Response to Reviewers

Manuscript ID: 26-0767

"Simultaneous Contact Selection and Planning for Contact-Rich Manipulation with Cascaded Optimization"

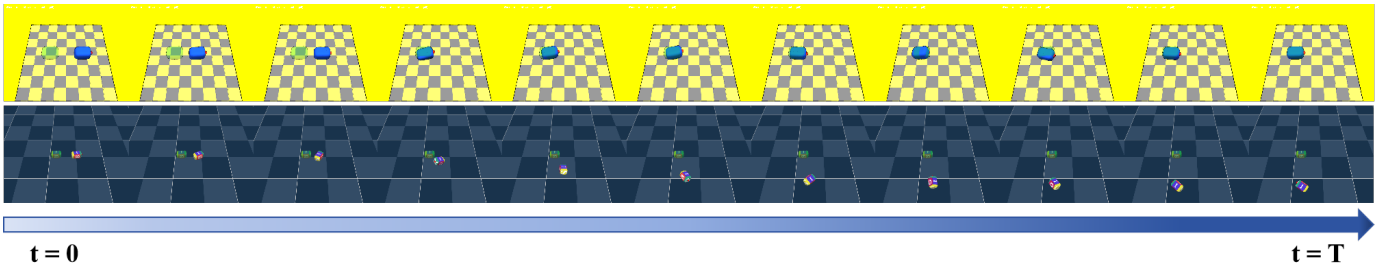
- STOCS / STOCS-3D: this is the closest prior work in spirit, since it directly addresses simultaneous trajectory optimization and contact selection with high-fidelity geometry. Even if it is not real-time, it should be used as an offline planning-quality reference or excluded with a clear justification.

We additionally include STOCS-3D and ContactSDF in the comparison. STOCS-3D is a CITO method that cannot be evaluated online in our setting and does not switch contact points during execution. Given the initial and target object poses, we compute one contact trajectory offline with STOCS-3D and execute it through OSC. ContactSDF provides a differentiable contact model but does not perform explicit contact selection. The resulting comparison is reported in Table II.
